Value Engineering Study Report

Project – CSNHS-M003-00(235) DeKalb, Rockdale County

I-20/SR402 Corridor Evans Mill Road to SR20/SR138

Value Engineering Study Report

DESCRIPTION: CHANGE CROSS SLOPE FROM 3/16/10/14 to 2% (1/4/10/5) HEET NO .:

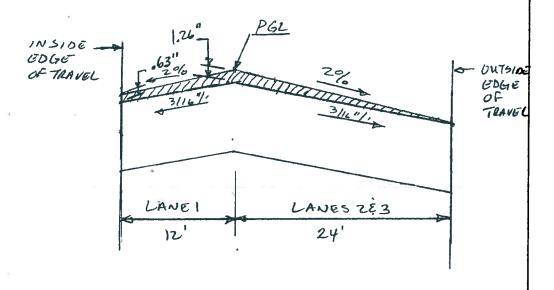
The original calls for changing the mainline cross slope from 3/16"/ft. (existing) to 2% (1/4"/ft.).

The suggested alternative design is to maintain the existing 3/16"/ft. cross slope.

The change in cross slope is accomplished by holding the outside edge of travel lane and increasing the cross slope toward the median; raising the Profile Grade Line by 1.26". This requires an additional 6,420 tons of asphalt. Increasing the cross slope by less than 1/16"/foot will only minimally improve drainage. Since the design also calls for the PEM surface treatment, cross drainage should be significantly improved.

EXISTING STAGE 3

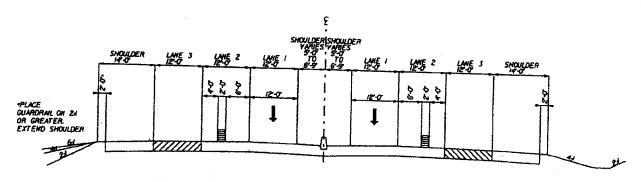
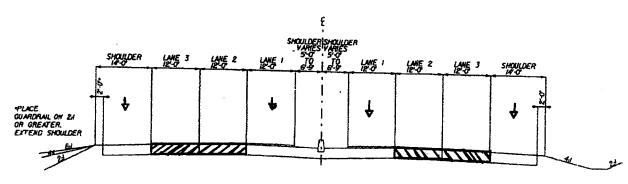
The design assumes that Stage 3 traffic will be shifted to the outside shoulder, permitting the reconstruction of Lane 2 with lane closures in Lane 3. Traffic will be down to one lane.

Stage 4 traffic shifted to the original configuration. This will permit the reconstruction of Lane 3 with lane closures in Lane 2. Traffic will be down to one lane.

The alternative would call for combining Stages 3 and 4 in a split traffic pattern. In this combined Stage, traffic will be placed in Lane 1, the outside shoulder, and either Lane 2 or 3, for a total of three lanes of traffic during non-work hours. With either Lane 2 or 3 permanently closed during non-work hours, single lane closures will provide access to both Lanes 2 and 3 during construction hours. Trucks will be instructed to utilize the outside shoulder during this stage.

SPLIT TRAFFIC STALLE - THREE LANGS OREN LANE 3 PERMANENTLY CLOSED

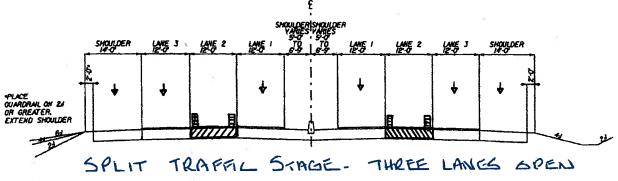
This is not the most desirable traffic handling procedure but could be beneficial on a limited basis.

DESCRIPTION: Retain all Existing Barrier

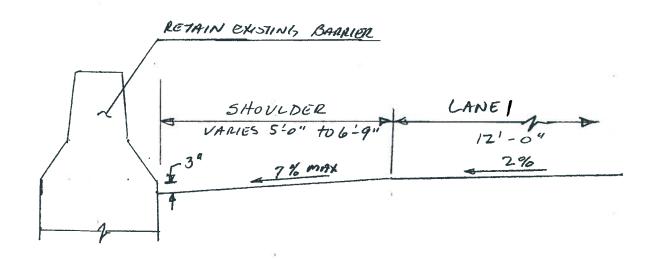
In the original design there is to be a change of cross-slope to 2% (1/4"/ft.) from the existing 3/16"/ft. This has the effect of raising the Profile Grade Line (PGL) elevation. The way in which the cross-slope is handled currently requires the replacement of the median barrier.

It is suggested that the design be changed so that the cross-slope of the inside shoulder maintains the full height, 3 inches, to the barrier reveal line. This would allow the concrete median barrier to be retained.

By increasing the slope of the inside shoulder to approximately 7%, the shoulder grade could be set to provide the full 3" height to the barrier reveal line. With the 2% downward slope of Lane 1 (3/16"/ft.), the breakover would be less than the maximum 8%, and the existing barriers could be retained.
